Subject: Limerick Generating Station, Units 1 and 2
Additional Information for Auxiliary Systems
Branch (ASB) Regarding SER Open Issue #2
(Tornado Missile Effects on Ultimate Heat Sink).

RESPONSE TO
QUESTIONS AND COMMENTS CONCERNING REPORT NUS-4507
LIMERICK GENERATING STATION, ULTIMATE HEAT SINK EXTREME
WIND HAZARD ANALYSIS

Figure 1. Straight Wind Hazard Curves

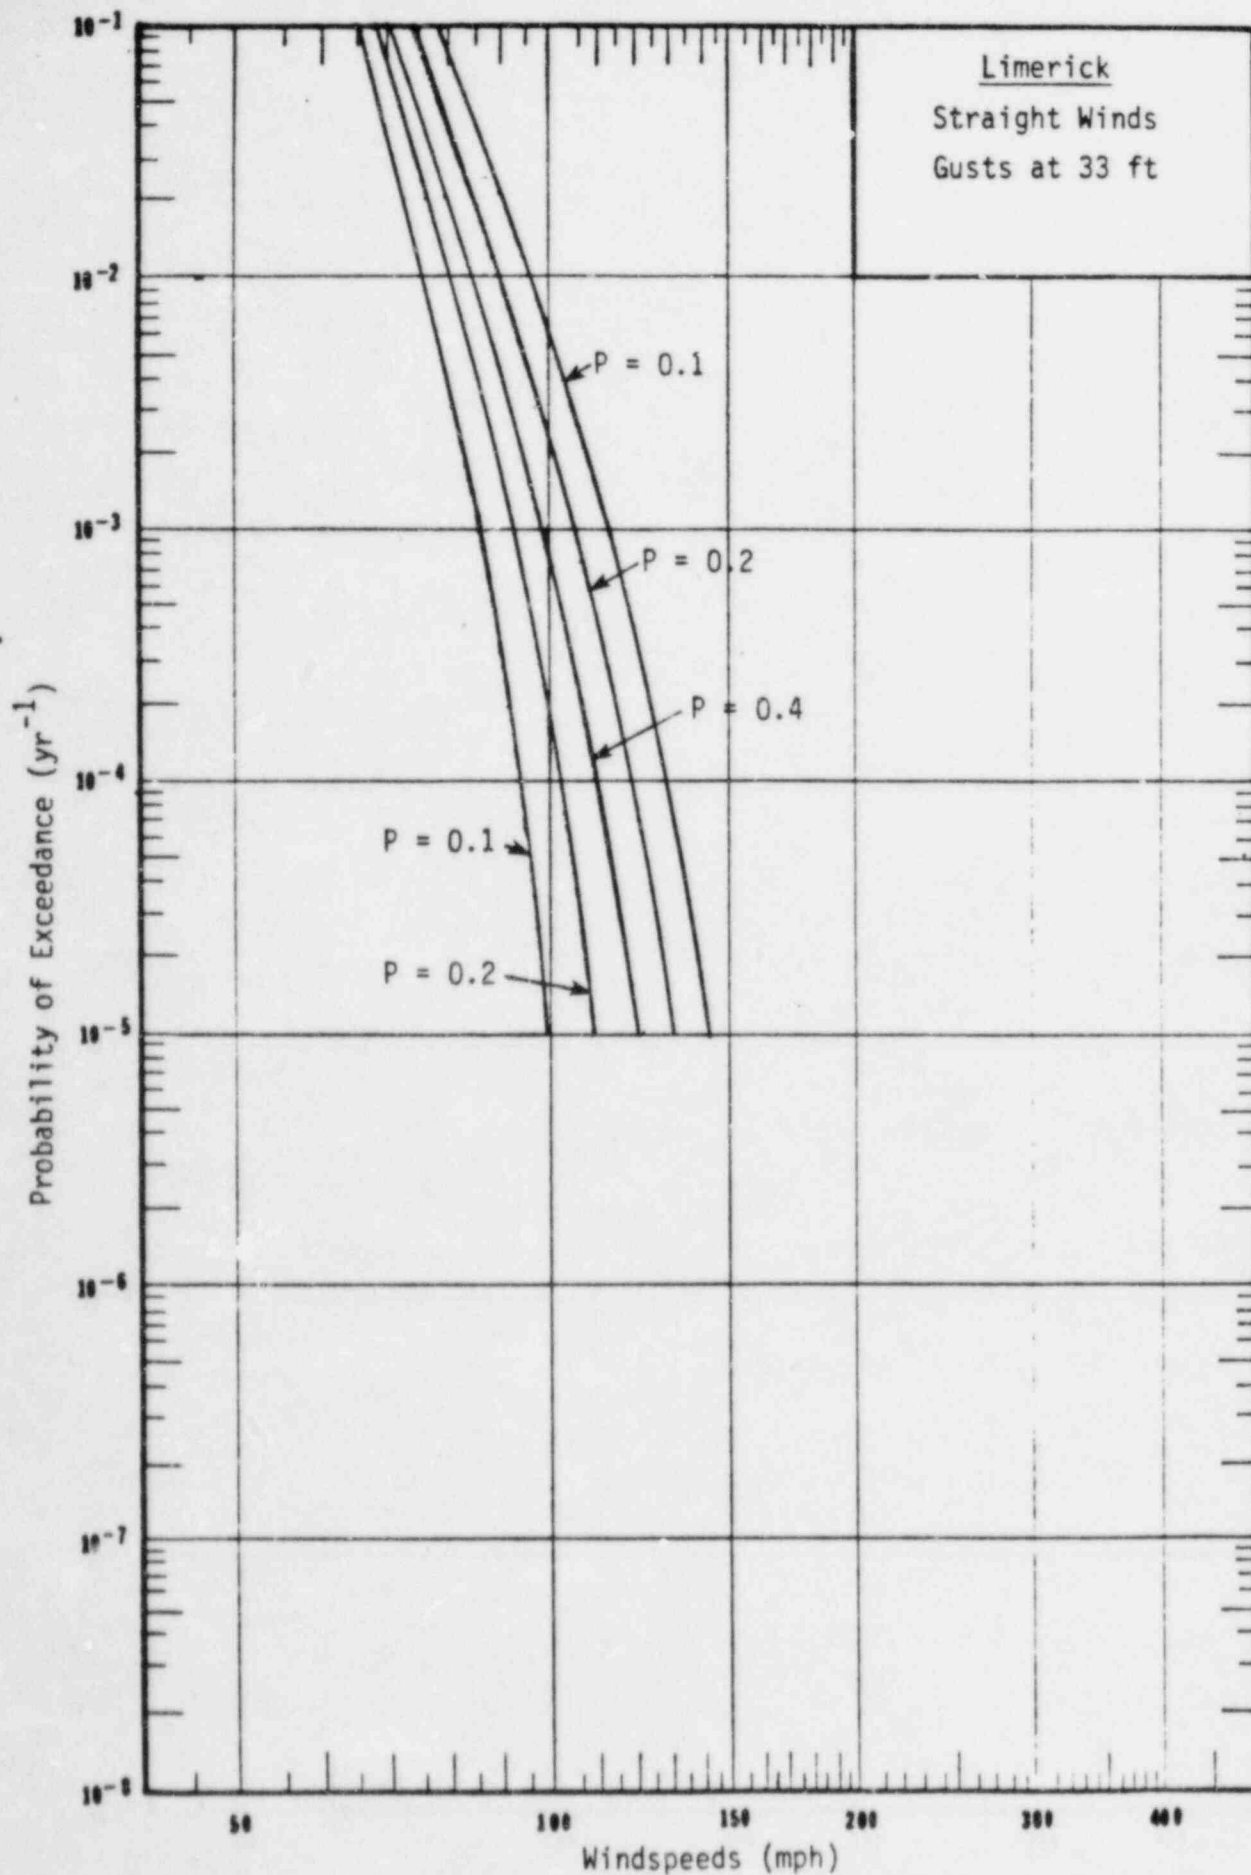
The probability distribution of extreme "straight" winds is estimated in the Report on the basis of a sample of only ten largest yearly wind speed data. The precision of the estimates based on a 10-data sample is, as a rule, unsatisfactory. For example, in the case of the Philadelphia Airport, the method of moments yields, for the estimated 2000-yr wind based on a 10-data sample, the 95 percent confidence interval 83.2 ± 23.0 mph (fastest mile) - see Extreme Wind Speeds at 129 Stations in the United States, NBS BSS 118, P. 235. The precision of the estimates would increase by a factor of $(23/10)^{1/2} = 1.52$ if all the 23 data available for the Philadelphia Airport station were used.

What is the expected effect of accounting for sampling errors in estimating "straight" and hurricane wind speeds upon the estimated frequencies of exceeding 10 CFR Part 100 limits?

It was indicated in the review meeting that the NRC staff had used the Harrisburg, Pennsylvania, data (39 years of record) curve in its preliminary investigation of Limerick. This curve produces windspeeds very similar to the Reading data. The effect of sampling error for the straight wind frequencies is illustrated in Figure 1

for the Reading data based on an equivalent 28 years of record, which is one-half of the actual record length at Reading. Hence, the sampling errors are effectively increased by $\sqrt{2}$ to account for extrapolation to the site. A family of curves is plotted based on normally distributed errors, which were computed using the method of moments. This family of curves is plotted at $\{\hat{\mu} - 1.76\hat{\sigma}, \hat{\mu} - 0.859\hat{\sigma}, \hat{\mu}, \hat{\mu} + 0.859\hat{\sigma}, \text{ and } \hat{\mu} + 1.76\hat{\sigma}\}$, which are the expected value locations of a discretized normal density with probabilities 0.1, 0.2, 0.4, 0.2, and 0.1, respectively.

Figure 2. Hurricane Hazard Curves

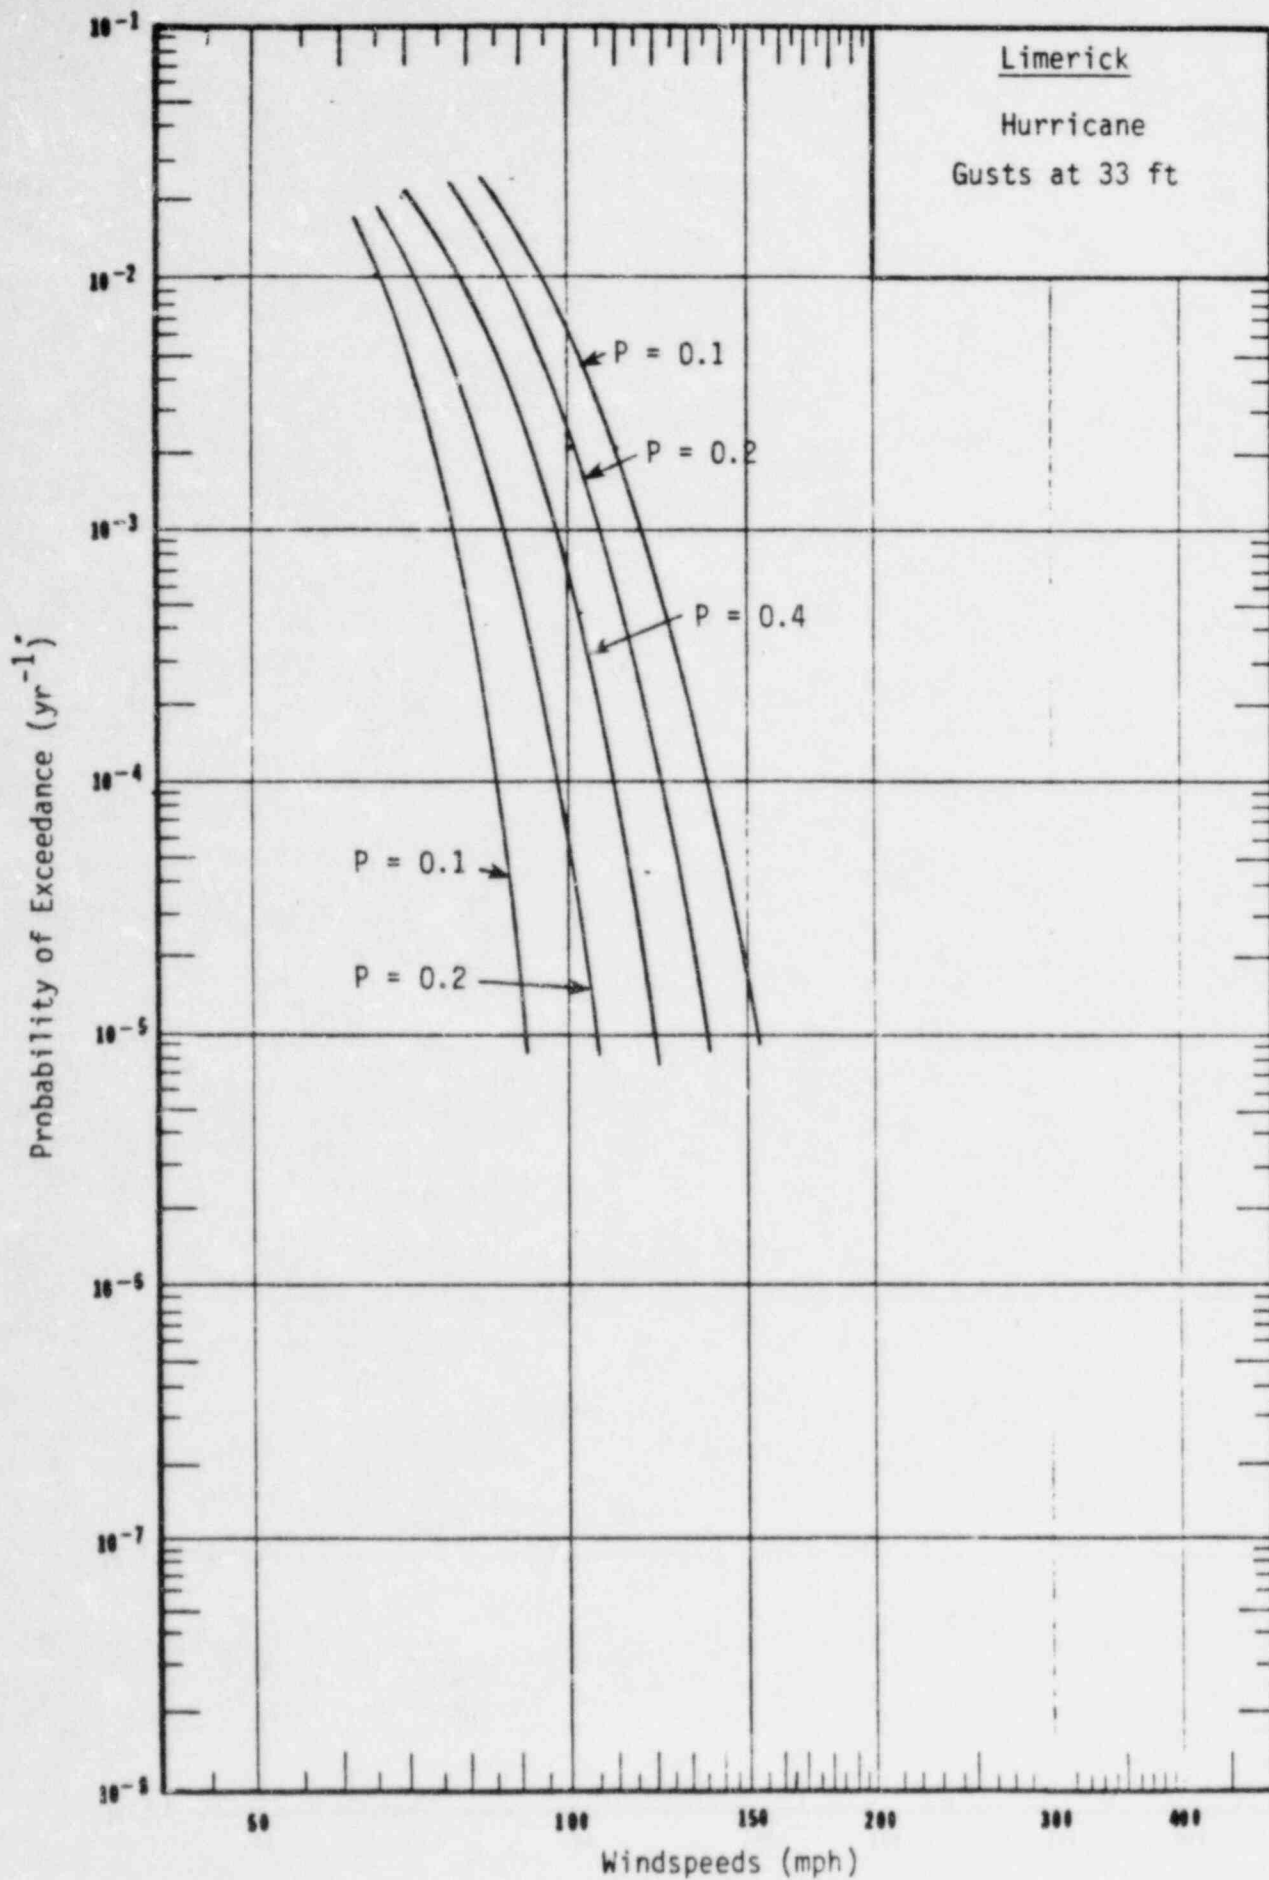
Sampling errors also are inherent in hurricane wind speed estimates (see Batts, et al., "Sampling Errors in estimation of Extreme Hurricane Winds," J. Str. Div., ASCE, October 1980, pp. 2111-2115).

(b) Hurricanes. Uncertainties in the hurricane curve for Limerick can be estimated using the results of the Batts et al. study. The following estimates of error are used:

Assuming that the results are linear and independent in these errors, the combined error can be estimated by summing the variance of each error source. One obtains $\hat{\sigma}_c = 0.117$ for $P(v > V^*) = 1 \times 10^{-2}$ and $\hat{\sigma}_c = 0.15$ for $P(v > V^*) = 2.5 \times 10^{-3}$. These uncertainties are plotted in fig. 2 for a discretized normal distribution with probabilities 0.1, 0.2, 0.4, 0.2, and 0.1. These uncertainties demonstrate a wider distribution than that estimated for the straight winds and thus tend to dominate the straight wind curves.

Figure 1

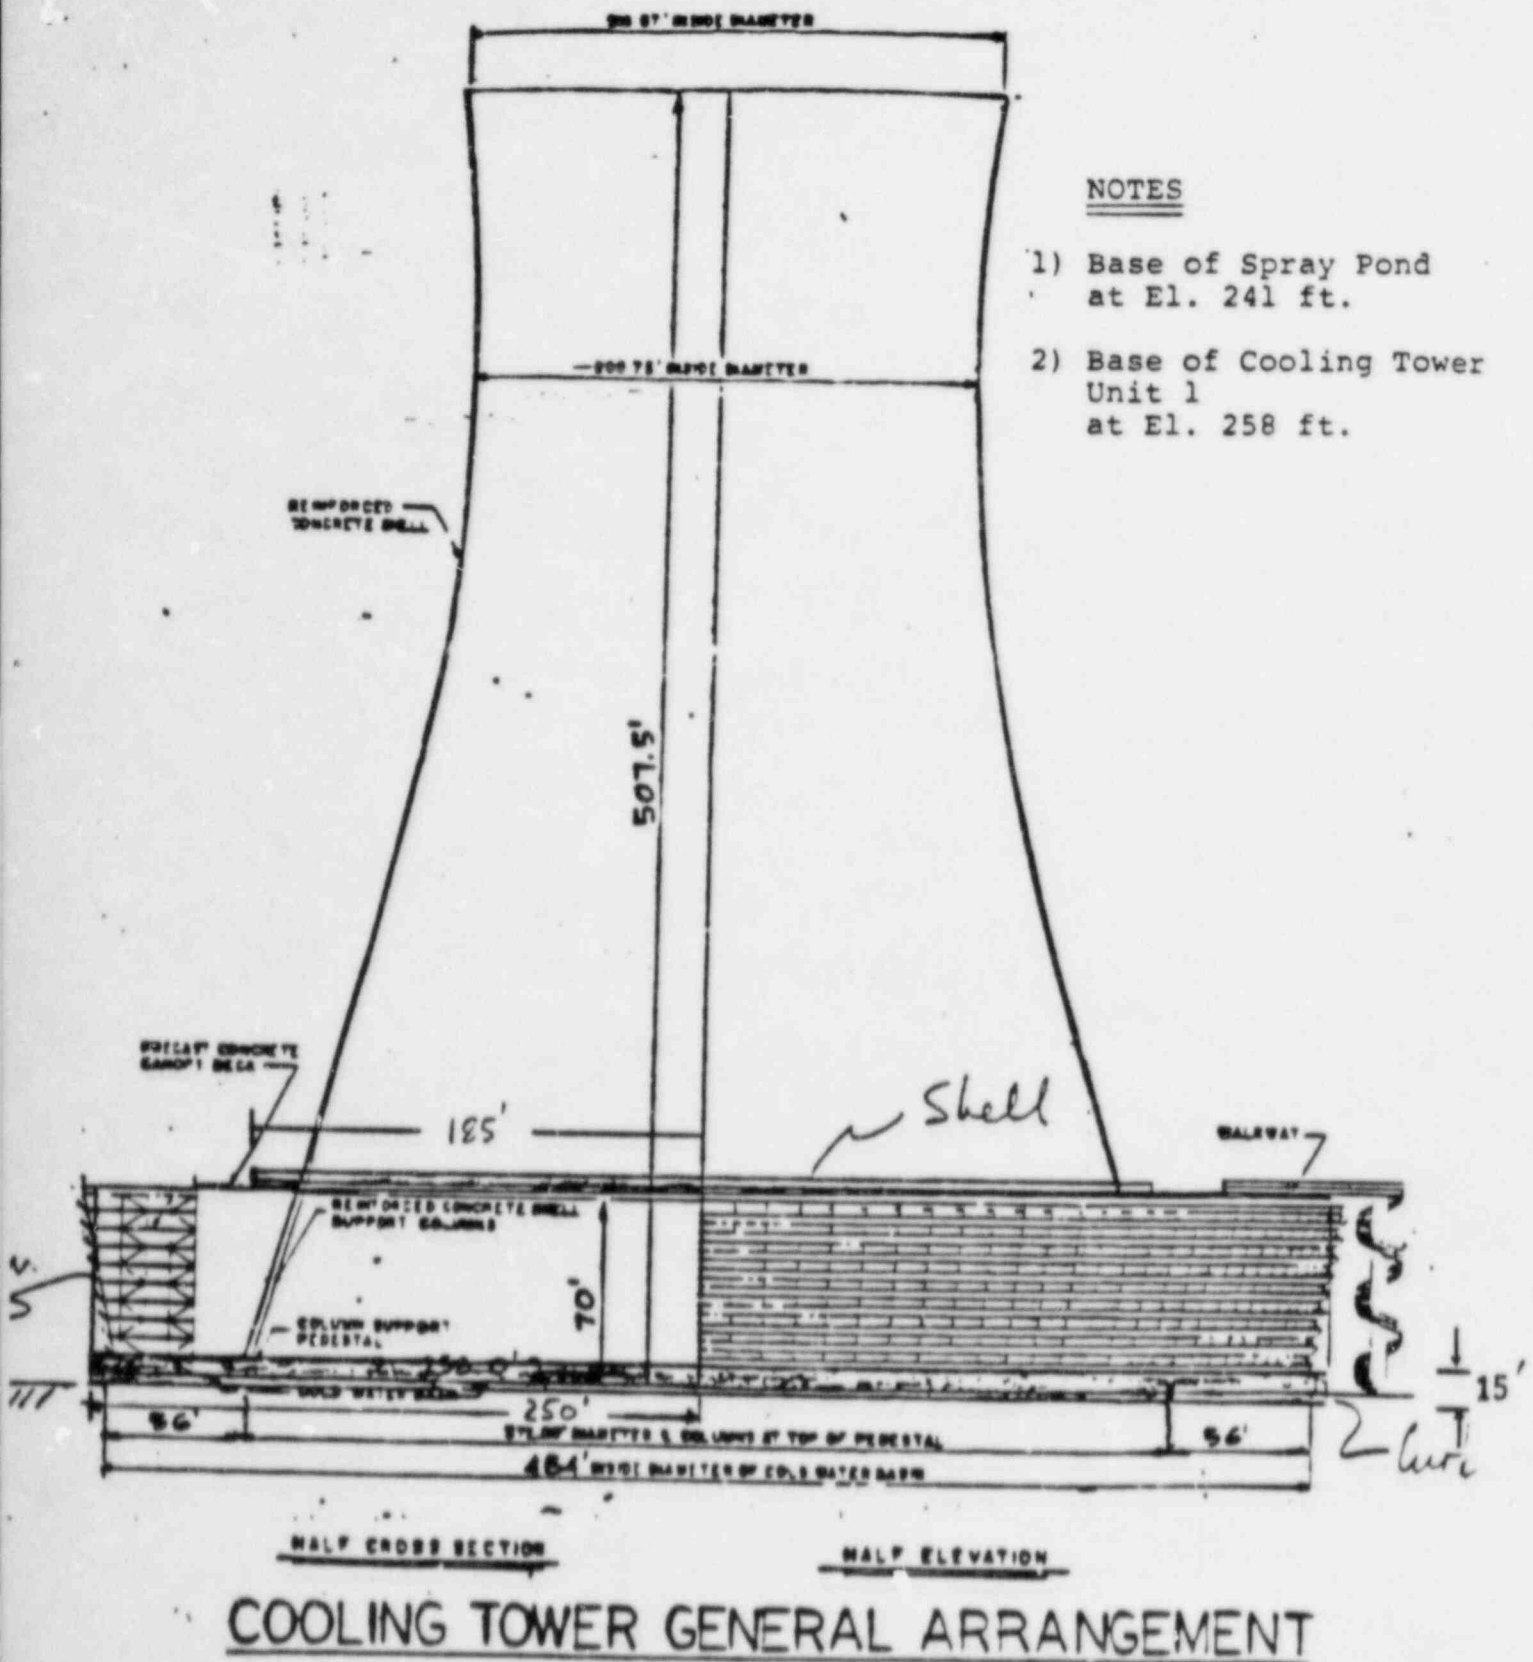
- a. What is the Report's definition of the basic wind speed? Is it the fastest-mile wind speed over open terrain?
- b. What is the precise definition of "designed for," i.e., was an allowable stress, or an ultimate stress approach used in the design of the tower for a basic wind of 90 mph?
- c. What are the heights of the towers? From p. 4-7 one might infer that they are 485 ft. Is this inference correct? What does the 500 ft elevation mentioned in line 2, Section 4.4.3.1 represent? A simple sketch of the towers should be included, indicating: the elevations of the top and bottom of the towers; the curb wall; and the fill areas.
- d. Is the 140 mph speed at which the towers are assumed to fail a speed averaged over 2 seconds?

- b. Allowable stress.
- c. See Figure 1.
- d. The TORMIS methodology conservatively simulates the peak windspeeds and tornados as steady-state winds. For example an F2 tornado with a peak wind of 150 mph (averaged over several seconds) would be simulated with a peak steady wind of 150 mph. The actual averaging time of peak tornado winds is generally felt to be on the order of several seconds since the tornado classification system is based on observations of structural damage. (Fujita assumes that the windspeeds in the F-scale are fastest quarter mile speeds.) Thus, the tower failure criteria is based on windspeeds without any explicit consideration of averaging time. If the centerline of the tower experiences windspeeds of any duration 140 mph at tower midheight the tower is assumed to fail.
